PRODUCT CHANGE NOTIFICATION (PCN)

AMJE0909-0050-WHB-24
MODULAR CABLE

CHANGE NOTIFICATION: PCN 20220509_AMJE0909-0050-WHB-24

AMJE0909-0050-WHB-24
DOCUMENT: DRAWING

AMJE0909-0050-WHB-24 OLD VERSION

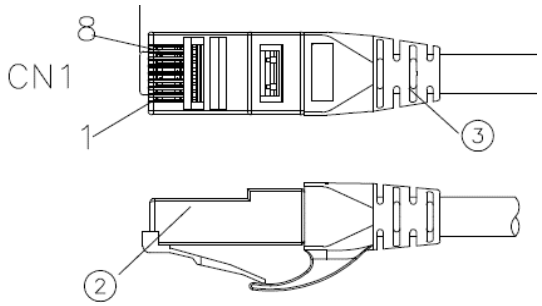
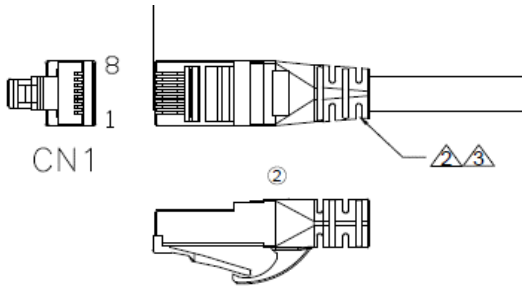
③	Molding	PVC 45P Color: see order code	NA	KG
②	CONNECTOR	RJ45 8P8C two fork Short type 3u" gold plated	2	PCS
①	CABLE	CAT6 UTP (24AWG*1PR)*4+PVC OD=5.8±0.3MM Color: see order code	NA	MM
NO:	NAME	DESCRIPTION	Q'TY	UNIT

3	Molding	PVC 65P Color: see order code ②	NA	KG
2	CONNECTOR	RJ45 8P8C PLUG 3u" gold plated ②	2	PCS
1	CABLE	CAT6 U/UTP (24AWG*1PR)*4+Cross+PVC Jacket OD=5.8± 0.3MM Color: see order code ②	NA	MM
NO:	NAME	DESCRIPTION	Q'TY	UNIT

Drawing-No.
ASS 7945 CA

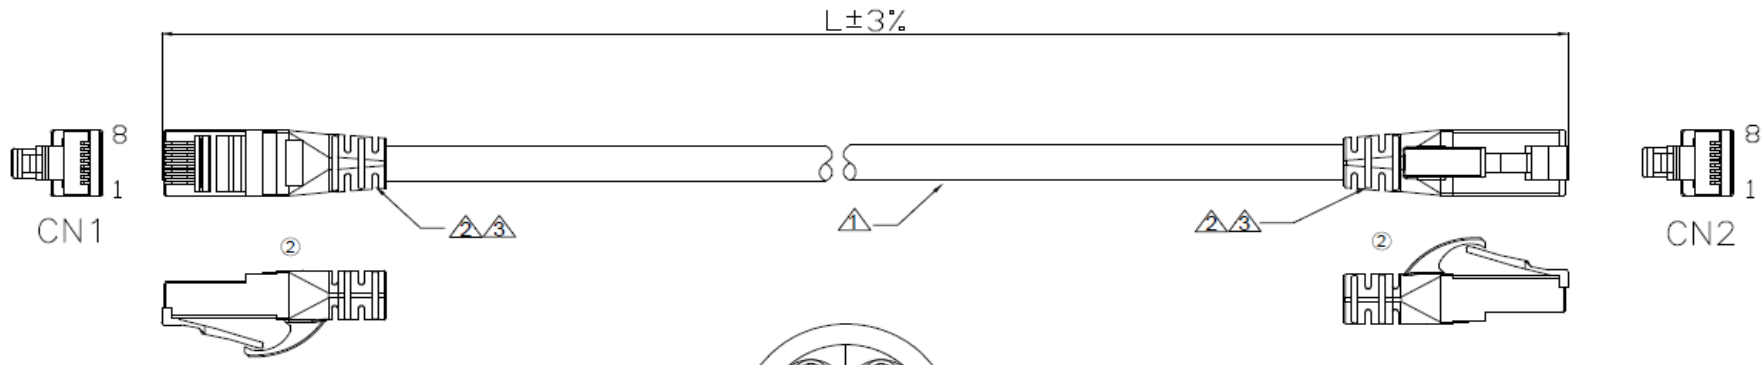
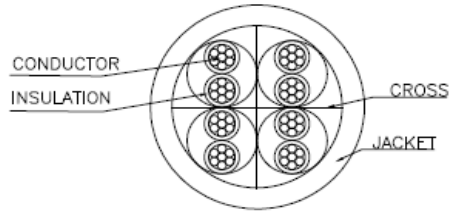
Id.	Modification	Date	Name
②	Change the plant	09.05.2022	Luca
①	Update the WSW order code	02.06.2017	Amy
⓪	Drawn	30.03.2017	Amy

NO:	NAME	DESCRIPTION	Q'TY	UNIT
3	Molding	PVC 65P Color: see order code ②	NA	KG
2	CONNECTOR	RJ45 8P8C PLUG 3u" gold plated ②	2	PCS
1	CABLE	CAT6 U/UTP (24AWG*1PR)*4+Cross+PVC Jacket OD=5.8± 0.3MM Color: see order code ②	NA	MM
